SUBJECT: Wake County, Davis Drive (SR 1613/SR 1999) from Morrisville-Capenter Road
(SR 3014) in Wake County to NC 54 in Durham County); T.I.P. Number U-4026;
State Project 9.8051713

SUBJECT: Action ID 2008-02065; TIP No. U-4026

In-Field Minor 401 Water Quality Certification, Buffer Certification and Isolated Waters Permit
Modification

Subject: Widening of Davis Drive (SR 1613/SR 1999) from Morisville-Carpenter Road in Wake County to NC 54 in Durham County. TIP No. U-4026.

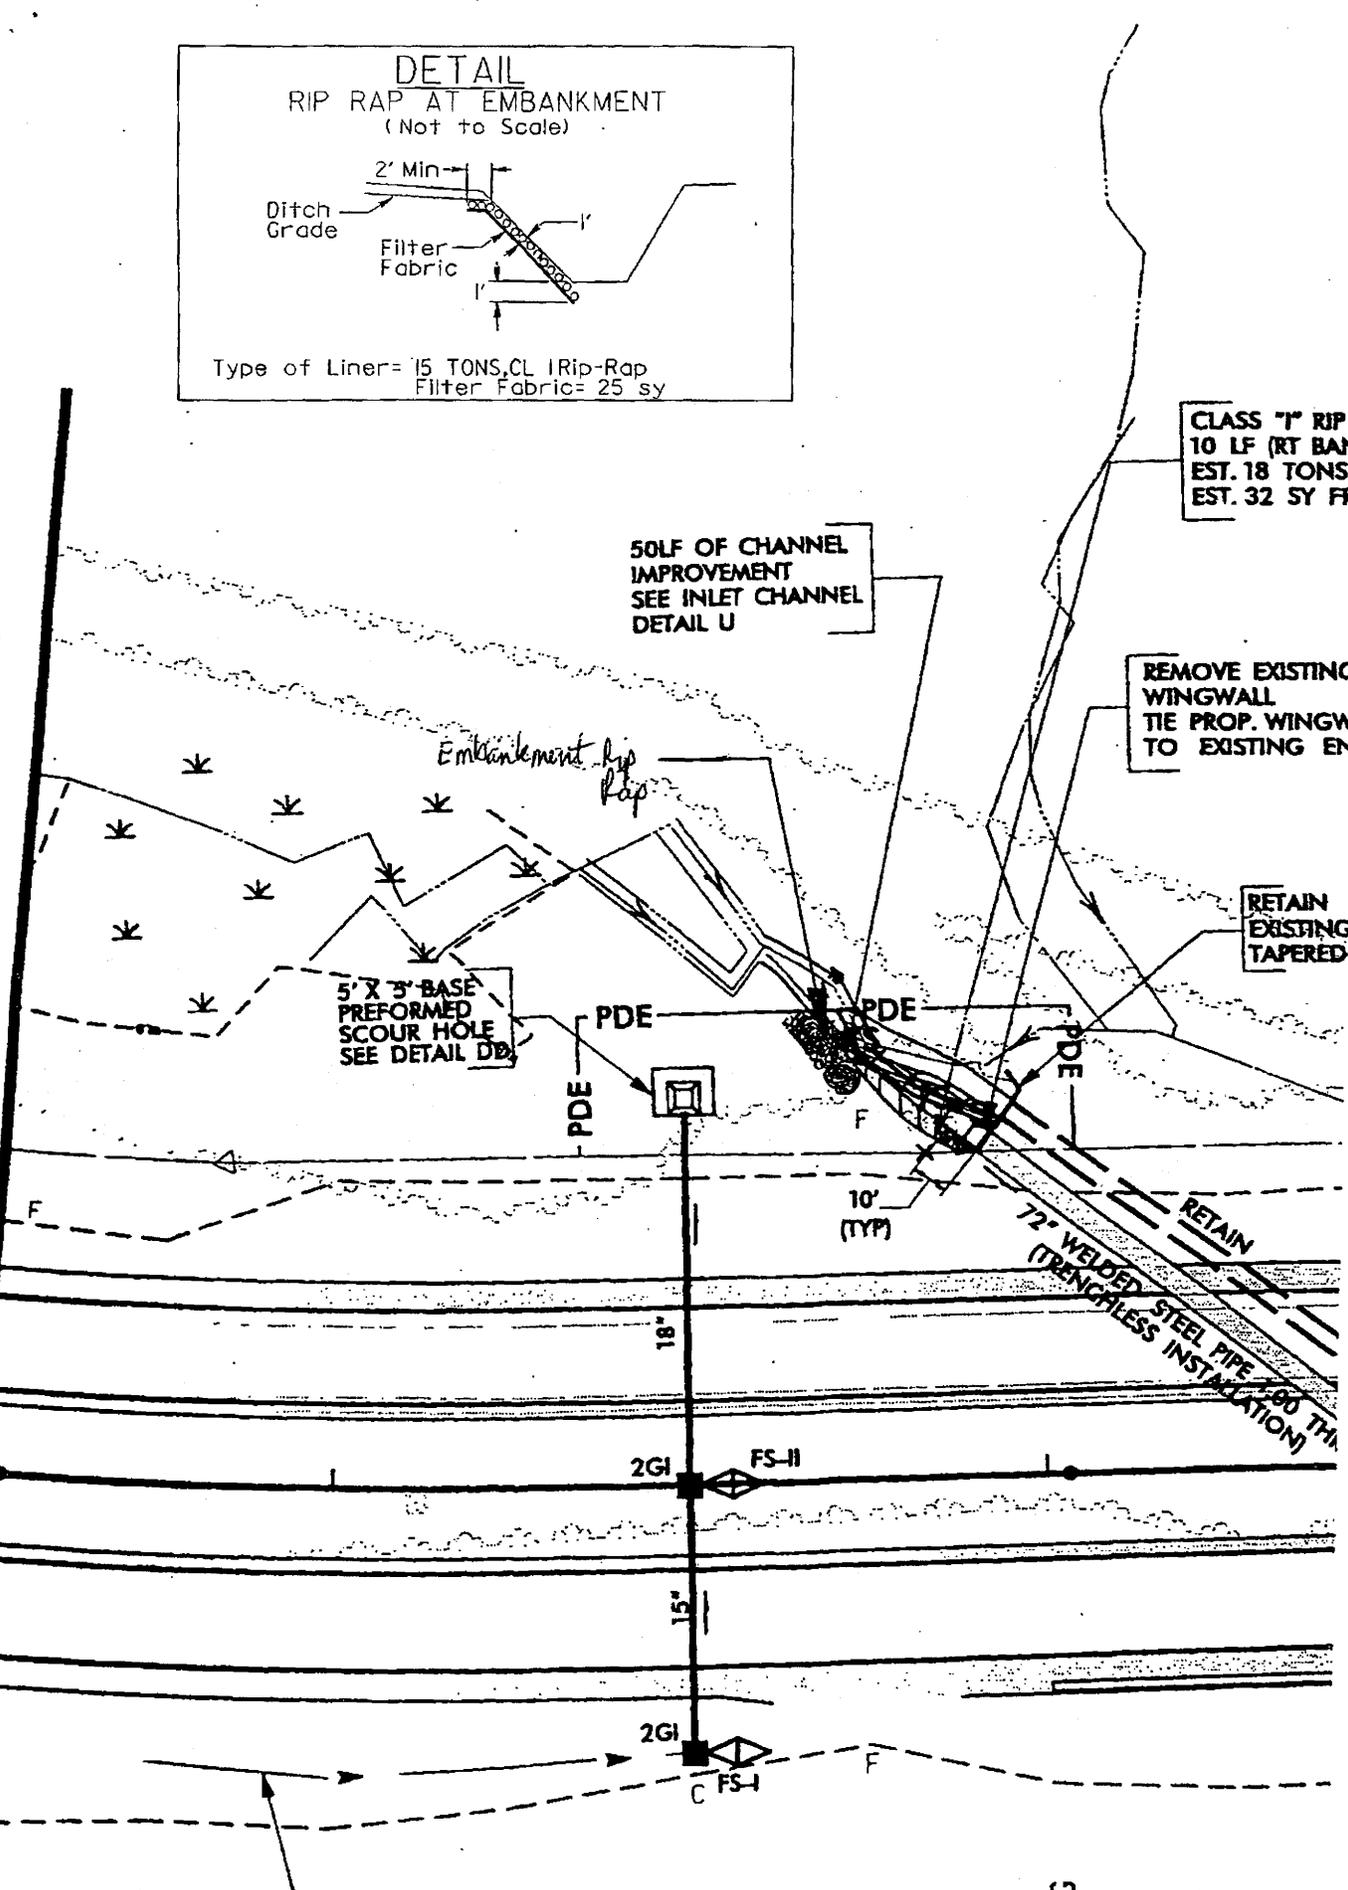
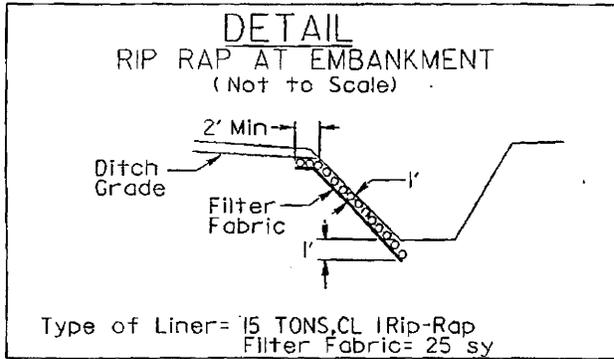
The North Carolina of Transportation (NCDOT) is currently constructing this project in Durham and Wake Counties. A stabilization issue has been observed at Station 132+10 Lt- L- (Permit Site No. 3, Permit Drawing Sheet 10 of 65). This issue is addressed below:

A pre-formed scour (PFSH) hole has been constructed at this location. The outer-most edge of the device is almost directly adjacent to an unnamed tributary to Kit Creek in the Cape Fear Basin (Jordan Lake Watershed). Runoff from the PFSH has caused formation of a scour on the streambank of the unnamed tributary. The Department proposes to place appropriate fill material into the scour and then construct a small, shallow, rip rap-lined swale that would extend from the outer-most berm of the PFSH to below the ordinary high water mark on the adjacent unnamed tributary. This will require the installation of up to 25 linear feet of Class I rip rap on the streambank. This activity is depicted on the attached sketch.

- Placement of the rip rap on the streambank below the ordinary high water mark will result in 25 linear feet of permanent stream impacts.
- Installation of this rip rap will occur on the streambank and will not affect aquatic life.
- Note that the stream has slightly shifted since the permit drawings were originally completed. The stream currently extends into the NCDOT right-of-way.
- Note that the icon depicting the PFSH is not to scale. Construction of the PFSH per the dimensions provided in Detail DD extends the outer-most edge of the device to the full extent of the PDE.
- The project is located in the Cape Fear River Basin (Jordan Watershed). Note that clearing of vegetation in the PDE was conducted in 2007.
- The proposed action does not involve additional impervious surface or additional runoff.

We have reviewed the proposed modifications, and determined that they are minor, that neither an additional public notice nor compensatory mitigation will be necessary. Therefore, the permit is hereby modified to include the riprap work as shown on the enclosed revised drawing. It is understood that all other conditions of the permit, including the permit expiration date of December 31, 2011, remain applicable.

Slightly modify outfall @ Permit Site 3 on Davis Drive Project
